DESIGN SPECIFICATION

NCC 2016 – VOLUME 1

Penrith City Council C/- Justin Long Design

Emu Plains Village – 4 Lawson Street, Emu Plains

Figure 2.1.1 –proposed floor plan

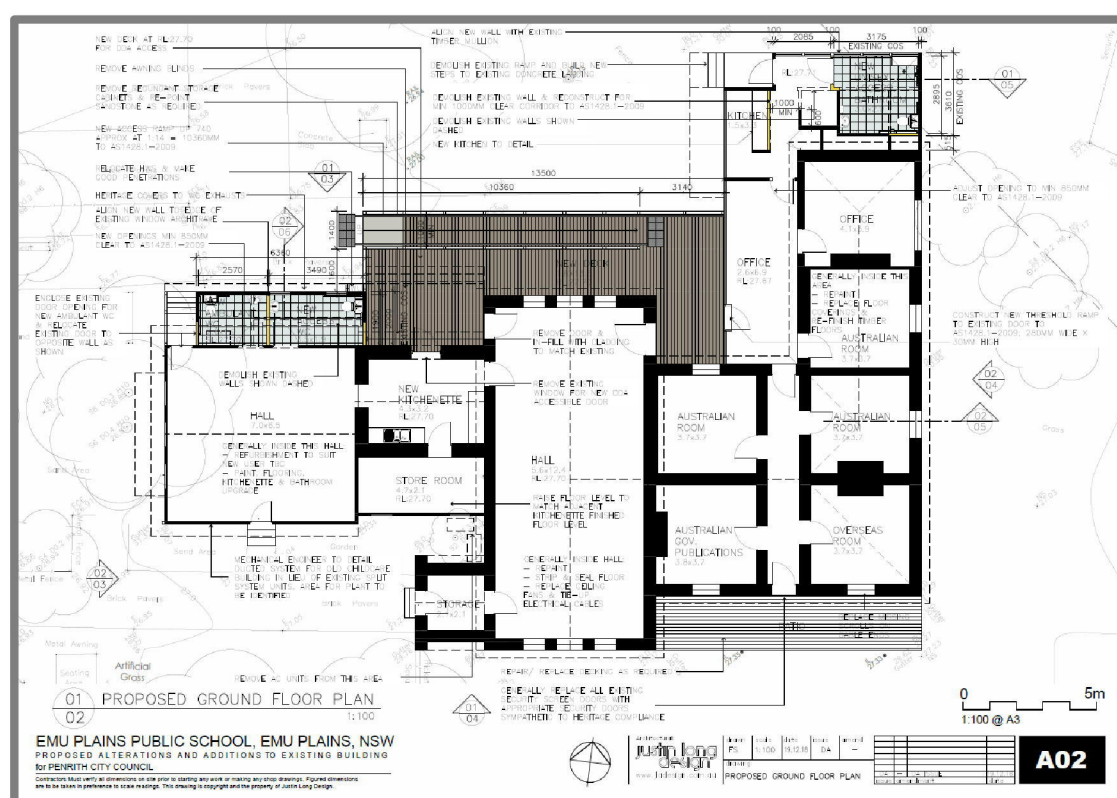
Based on the proposed number of sanitary facilities depicted in the design, the following population loads are accommodated –

It has been assumed that one of the new facilities is for male patrons, and the other is for female patrons.

The doorway openings to the new sanitary facilities in the hall space must be screened from view from occupants of the hall space.
